Product Similarity Declaration

We, TECNO MOBILE LIMITED, hereby declare that we have a product named as Mobile Phone, Model: LF7, FCC ID: 2ADYY-LF7, has two versions, Hardware version: V1.2 and Hardware version: V1.2, the PCB of those two versions has partial minor circuitry of non-transmitter portions was difference, version 2.1 was tested by Shenzhen Accurate Technology Co., Ltd., The differences between the two versions are as follows:

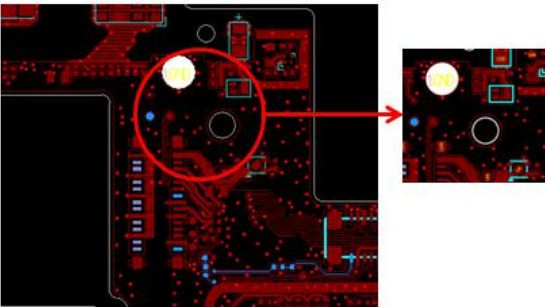
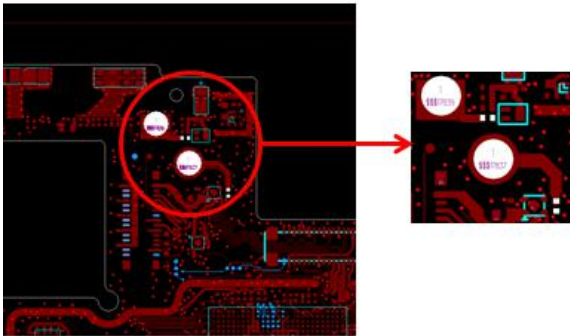
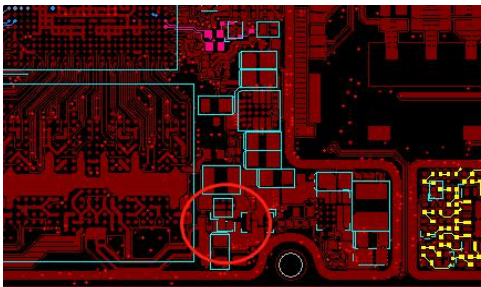
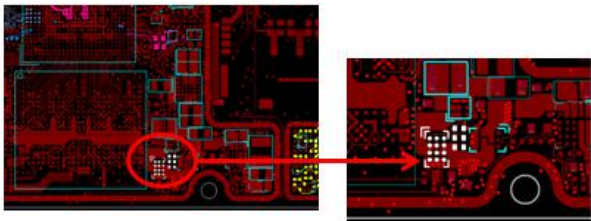
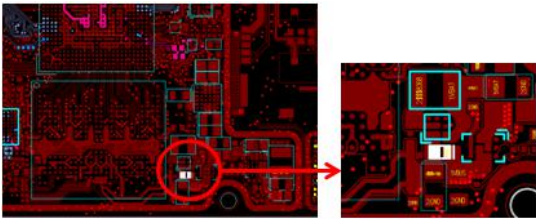
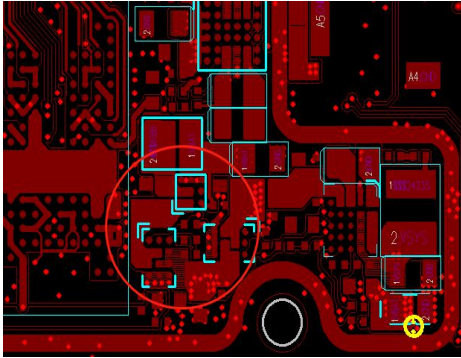
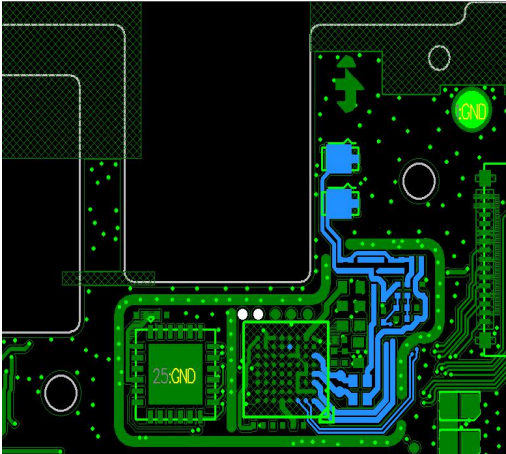
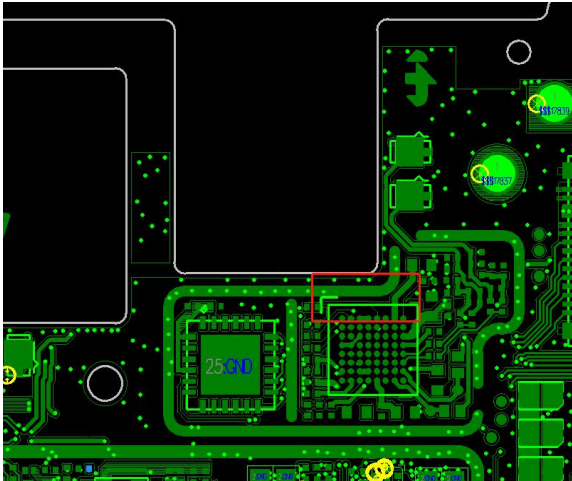
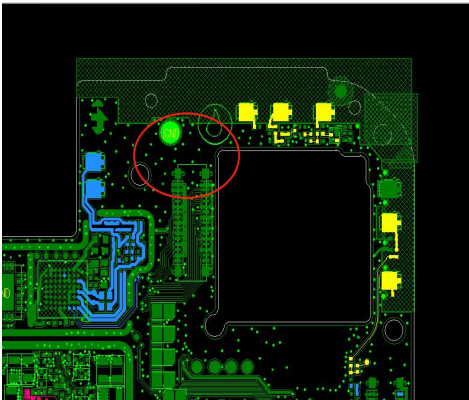
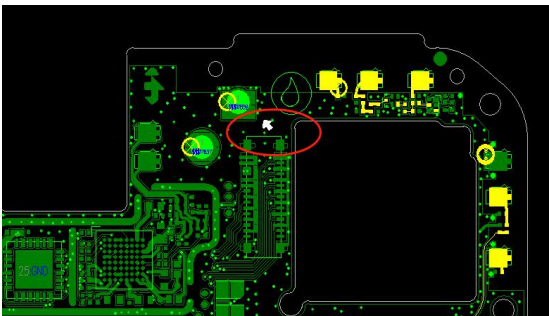
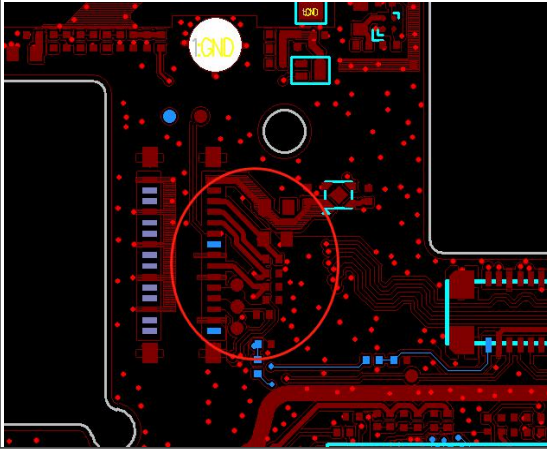
Hardware version	V1.2	V2.2
HOLE1 and HOLE2 are changed to AC grounding		
C2326 changed to 0402 package, withstand voltage 16V capacitor, C2320 changed to 0402 package, 10UF capacitor; Add reverse

charging OVPU2307 and enable foot pull-up resistor 10K, VIO18_PMU, and connect to GPIO39		
Remove D2302 Schottky diode		
Delete test points TP1203 and TP1204		
Add lock plate screw identifiers ARROW1001 and ARROW1002

Added compatible LDO U2212, as well as input and output capacitors C2240, C2241, path resistance R6270
